**PROPOSED AMENDMENT TO THE APPROVED KWU TUNG SOUTH OUTLINE ZONING
PLAN NO. S/NE-KTS/22 FROM "AGRICULTURE" ZONE AND "GREEN BELT" ZONE TO
"GOVERNMENT, INSTITUTION OR COMMUNITY" ZONE AT VARIOUS LOTS IN D.D. 94, 98, &
100 AND ADJOINING GOVERNMENT LAND, KWU TUNG SOUTH, NEW TERRITORIES
(TPB Ref. Y/NE-KTS/18)**

Proposed Amendment to the Approved Kwu Tung South Outline Zoning Plan No. S/NE-KTS/22 From “Agriculture” Zone and “Green Belt” Zone to “Government, Institution or Community” Zone at Various Lots in D.D.94, 98 & 100 and Adjoining Government Land, Kwu Tung South, New Territories (TPB Ref. Y/NE-KTS/18)
Responses to Comments Table

Responses to Comments Table

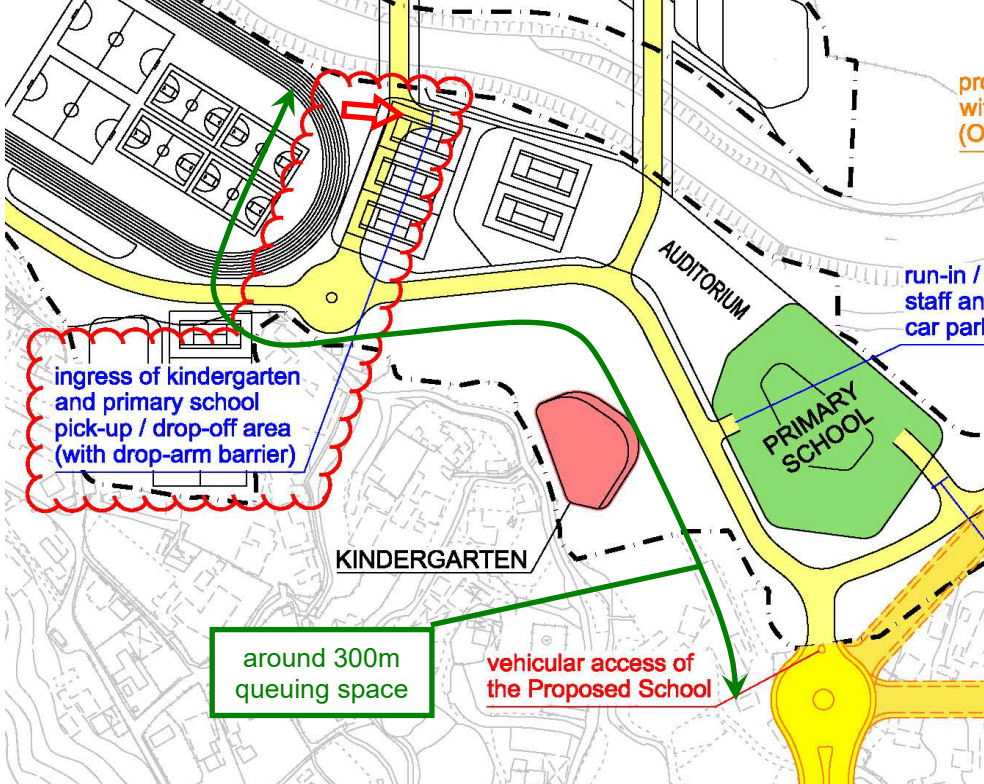
d. Consideration should be given to the potential mismatch in the commissioning timelines of the proposed school and NMH. If the San	There is no intention to commence operation of the Proposed School prior to the commission of the NMH. The Proposed School <u>will only open for operation after</u>

Comments/ Suggestions	Applicant/ Consultant's Responses
Tin section of NMH is commissioned after the school, please advise on the vehicular access arrangement for the school. Relevant traffic assessment to local road networks should be reviewed and included in the submission. e. A traffic flow split diagram should be provided to indicate the ingress and egress routes for traffic generated by the proposed school, for both scenarios: connection to NMH and connection to the local road network in case NMH is delayed. f. Section 3.18 – It is noted that approximately 300 meters are proposed within the school for queuing of vehicles. However, according to the master layout plan attached in the planning application, the proposed location of the kindergarten and primary school is close to the vehicular access. Please clarify the location of the pick-up and drop-off area for private cars for the kindergarten and primary school, and demonstrate that parent vehicles will not queue back to the local road and slip road of the NMH.	<u>commissioning of the San Tin Section of Northern Metropolis Highway</u>, tentatively scheduled for 2036. Given that the design of San Tin Technopole Interchange is ongoing and is yet to be finalised, the Project Proponent will liaise with Highways Department once a clearer picture is available. At the planning stage, it is anticipated that the Proposed School will generate insignificant traffic volume onto the Northern Metropolis Highway (NMH) as boarding facilities will be provided for senior primary (i.e. middle school) and secondary school (i.e. high school) students. The Proposed School will only commence operation once NMH is operational and it is not intended to connect to local road network. As shown in the below diagram extracted from Figure 3.1 of the submitted Traffic Review Report in Appendix 4, the ingress of pick-up / drop-off area for kindergarten and primary school (<u>indicated in red coloured cloud and red arrow</u>) is located around 300m from the vehicular access:

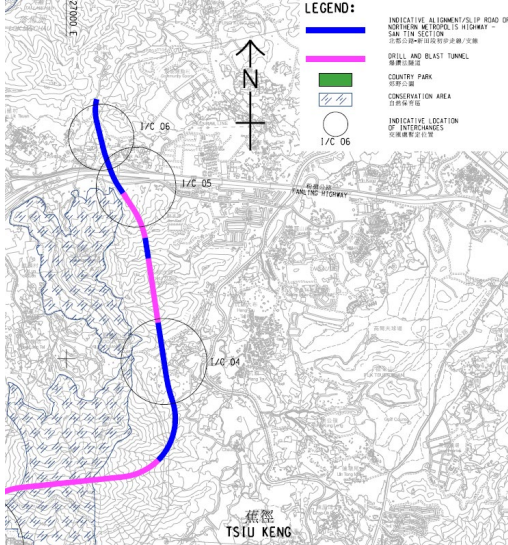
Comments/ Suggestions	Applicant/ Consultant's Responses
3. The ecological review at Appendix 6 is preliminary in nature and cannot support evaluations of potential ecological impacts arising from the proposed development at this stage. The applicant is advised to conduct a detailed ecological impact assessment (EcoIA) including ecological baseline surveys covering the wet and dry seasons. For general requirements for an EcoIA, reference should be made to Annexes 8 and 16 of the Technical Memorandum on Environmental Impact Assessment Process and Environmental Impact Assessment Ordinance Guidance Notes No. 7/2023 and No. 10/2023. The EcoIA should also take into account how construction materials will be transported to the site and whether any haul roads or traffic roads will need to be constructed by the applicant for the proposed development.	The Rezoning Site is not considered ecological sensitive with reference to the findings on the agricultural uses of two relevant studies in the vicinity, namely: (1) The 'Report on Preliminary Technical Study (Final) – Engineering Feasibility Study for the Establishment of an Agricultural Park – Feasibility Study (Feb 2017) (2) Northern Metropolis Highway – San Tin Section (Project Profile) under EIAO, April 2025 In particular, the proposed Interchange No. I/C 04 is located next to the Site, as indicated below.

Drawing Title	FULL PHASE – MASTER LAYOUT PLAN
Project No.	25018NT
Scale	1:1000
Issue Date	NOV 2025
Drawing No.	A/GBP_01_

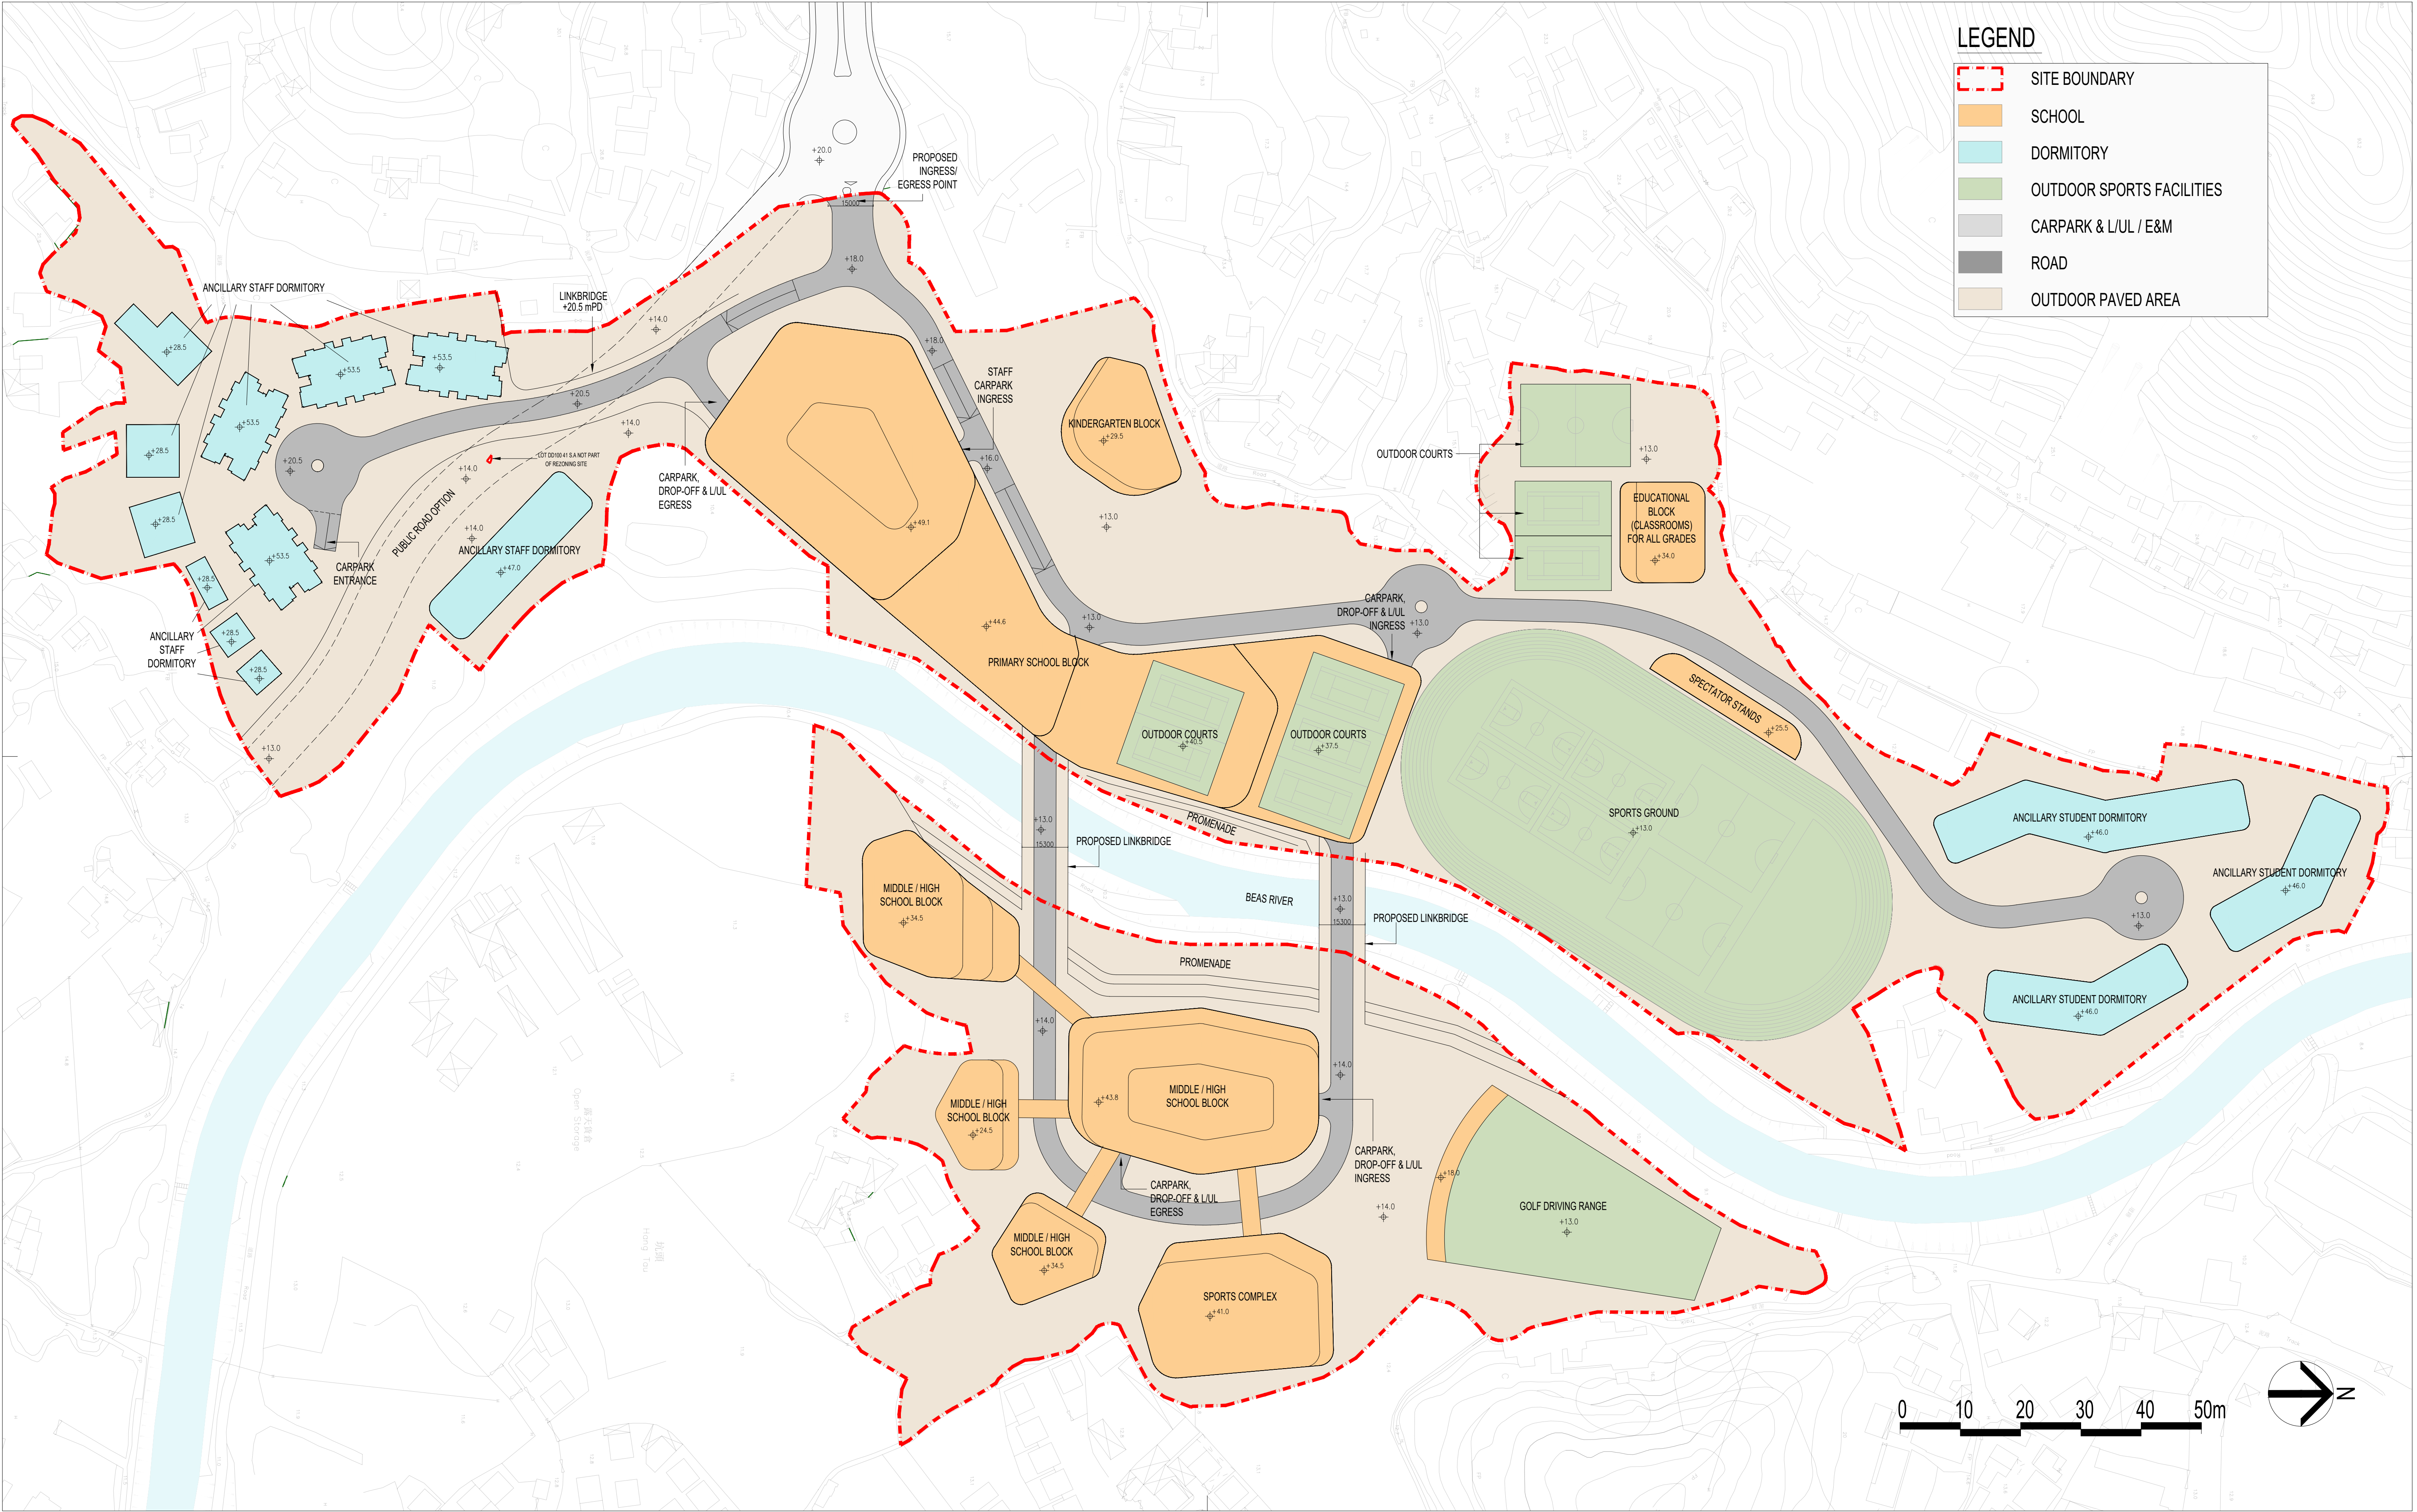
5.	Master plan - Please advise if there are any piers for the proposed link bridges within the Beas River.	Please be advised that no piers are proposed for the two link-bridges across Beas River. The Master Layout Plans of the Indicative Development Scheme are also supplemented in Annex 1 of the DIA (Attachment 3 refers).
